LASALLE COUNTY STATION, UNIT 1

AMENDMENT TO FACILITY OPERATING LICENSE

Amendment No. 59
License No. NPF-11

ENCLOSURE TO LICENSE AMENDMENT NO. 59

BASES FIG. A E B 3/4.6.2-1

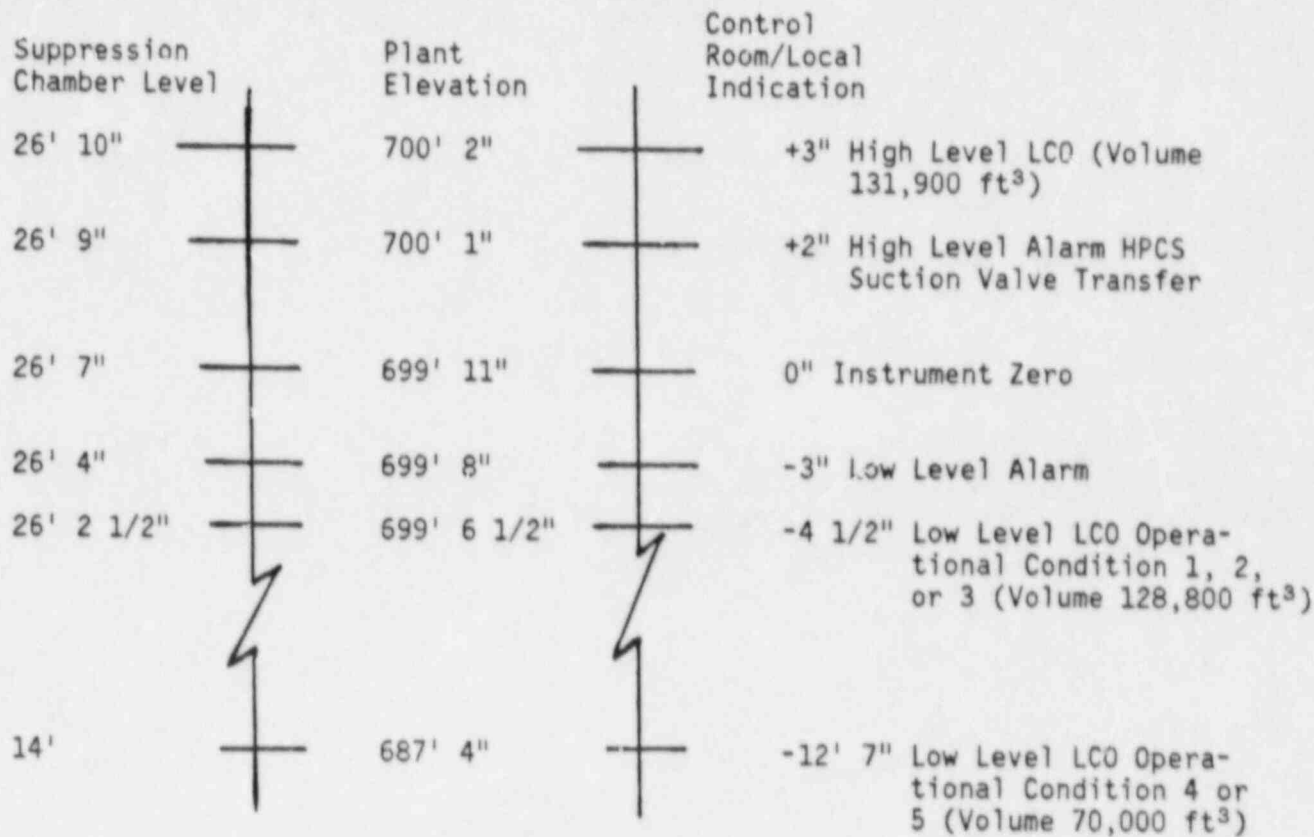
**Level is referenced to a plant elevation of 699 feet 11 inches (See Figure B 3/4.6.2-i).

**Level is referenced to a plant elevation of 699 feet 11 inches (See Figure B 3/4.6.2-1).

^{**}Level is referenced to a plant elevation of 699 feet 11 inches (See Figure B 3/4.6.2-1).

The suppression chamber water provides the heat sink for the reactor coolant system energy release following a postulated rupture of the system. The suppression chamber water volume must absorb the associated decay and structural sensible heat released during reactor coolant system blowdown from 1020 psig. Since all of the gases in the drywell are purged into the suppression chamber air space during a loss of coolant accident, the pressure of the liquid must not exceed 45 psig, the suppression chamber maximum pressure. The design volume of the suppression chamber, water and air, was obtained by considering that the total volume of reactor coolant and to be considered is discharged to the suppression chamber and that the drywell volume is purged to the suppression chamber. (See Figure B 3/4.6.2-1)

BASES FIGURE B 3/4.6.2-1

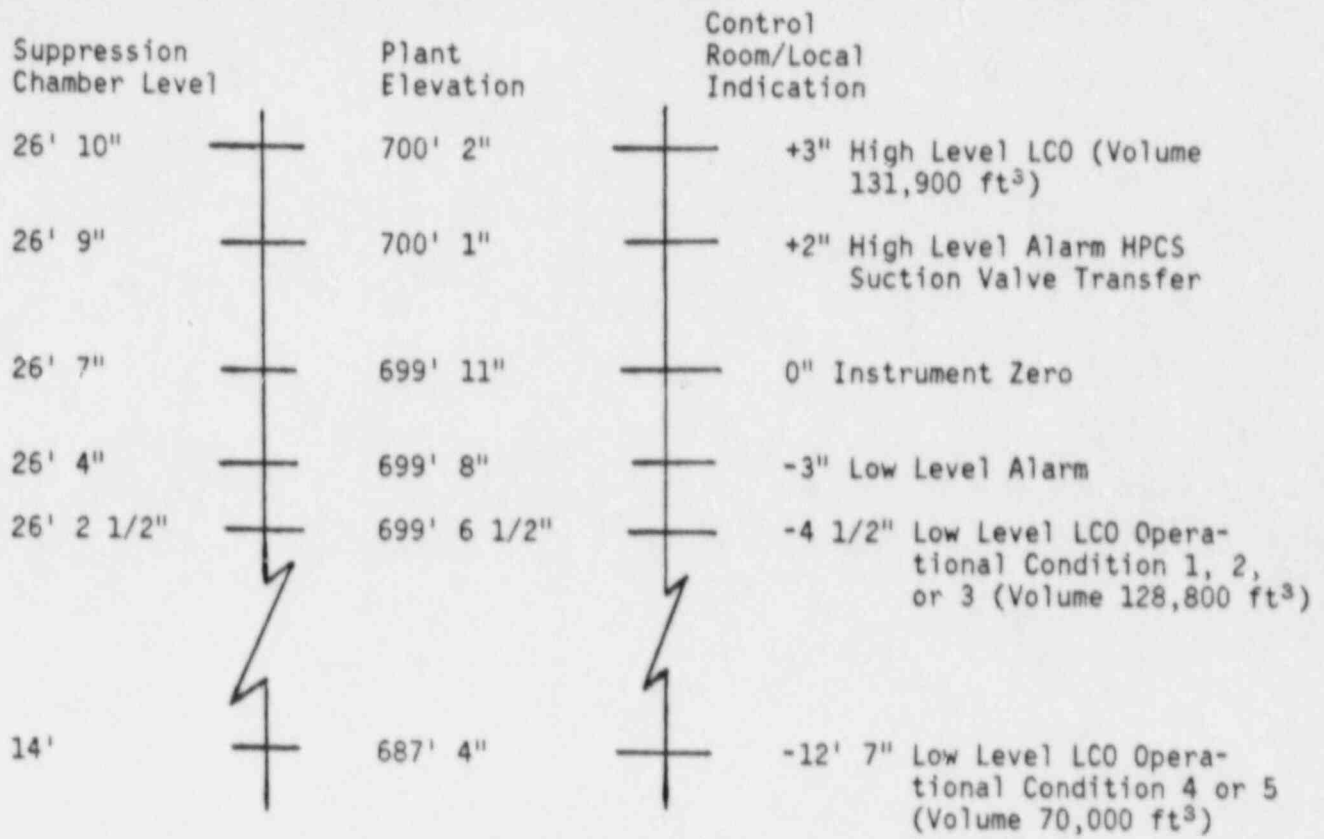
**Level is referenced to a plant elevation of 699 feet 11 inches (See Figure B 3/4.6.2-1).

**Level is referenced to a plant elevation of 699 feet 11 inches (see Figure B 3/4 6.2-1).

**Level is referenced to a plant elevation of 699 feet 11 inches (See Figure B 3/4.6.2-1).

The suppression chamber water provides the heat sink for the reactor coolant system energy release following a postulated rupture of the system. The suppression chamber water volume must absorb the associated decay and structural sensible heat released during reactor coolant system blowdown from 1020 psig. Since all of the gases in the drywell are purged into the suppression chamber air space during a loss of coolant accident, the pressure of the liquid must not exceed 45 psig, the suppression chamber maximum pressure. The design volume of the suppression chamber, water and air, was obtained by considering that the total volume of reactor coolant and to be considered is discharged to the suppression chamber and that the drywell volume is purged to the suppression chamber. (See Figure B 3/4.6.2-1)
